## Proposal for the 01 series of amendments to UN Regulation No. 178 (Emergency Lane Keeping Systems)

The text reproduced below was prepared by the expert from Australia proposing the 01 series of amendments to United Nations Regulation No. 178 (Emergency Lane Keeping Systems). The proposed amendments clarify some of the existing text, and include reference to the lane markings of the 01 series of UN Regulation 130. The modifications to the existing text of the Regulation are marked in red bold for new characters and red strikethrough for deleted characters.

*Figure 1: An example of the test path.”*

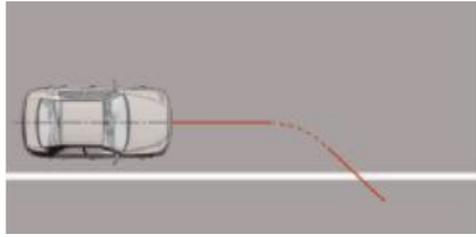
*Paragraph 8.3.3.1.2., amend to read:*

“8.3.3.1.2. A test path shall be driven which consists of an initial straight path parallel to the solid **line** lane markings being tested, followed by a fixed radius curve to apply a known lateral velocity and yaw to the subject vehicle, followed again by a straight path without any force applied on

the steering control (e.g. by removing the hands from the steering control).
